## Propeller Shaft Seal – 40, 50, and 75 HP

1998 Force 40, 50, and 75 HP

Serial Number – 0E311411 thru 0E313993

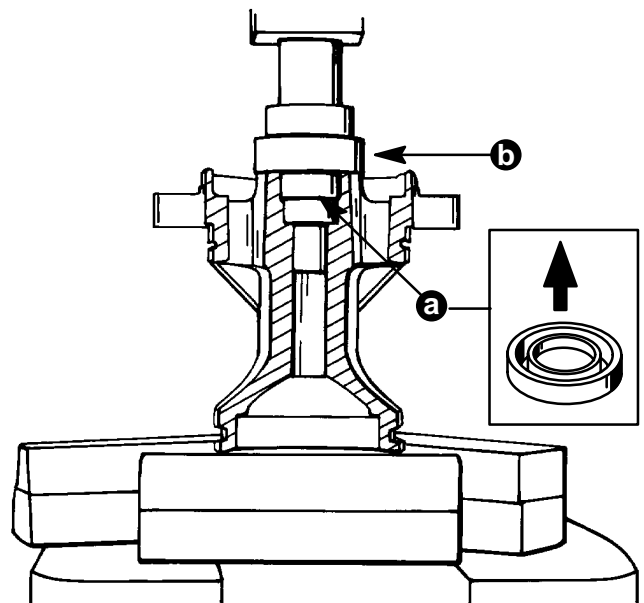
Replace the outer propeller shaft seal on outboards within the serial numbers listed that have not been reworked at the factory. It will be necessary to remove the bearing carrier from the gear housing. Remove and replace only the outer propeller shaft seal. The outer seal is installed with the seal lips facing out. Apply grease between the two seals for extra durability. Refer to the service manual for proper seal installation instructions. Paint the end of the propeller shaft white to identify the installation of the new seal.

a - Outer Seal

b - Mandrel 91-817007

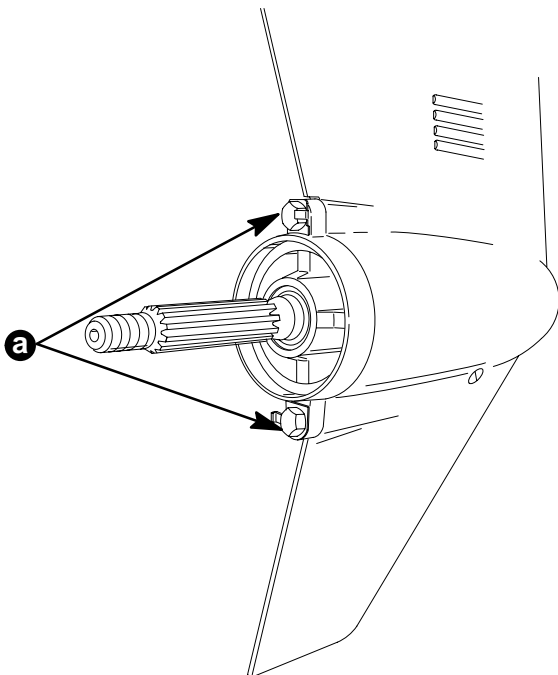
**Bearing Carrier Installation:** This new service information applies to all the models listed in this service bulletin. Installation of the bearing carrier requires replacement of the original washers and bolts. This change allows for an increase in the bearing carrier bolt torque. Discard any locking tab washers or the previous 0.063 in. (1.60 mm) thick flat washers and the previous 25 mm long bolts. They should be replaced with new 0.090 in. (2.29 mm) thick flat washers p/n 12-855941 and longer 30 mm bolts p/n 10-855940-30. The bolts should be torqued to a higher specification of 225 lb. In./18.7 lb. Ft. (25.4 N·m). The service manuals will have the new procedures and revised torque specification included in the next revision.

### Discard

Tab Washer  
14-826613

Flat Washer  
12-70132  
.063 in (1.60 mm)

Bolt  
10-40003-53  
30 mm Long

### Install

Flat Washer  
12-855941  
0.090 in. (2.29 mm)

Bolt  
10-855940-30  
30 mm Long

a - Torque Bolts to 225 lb. In./ 18.8 lb. Ft. (25.4 N·m).
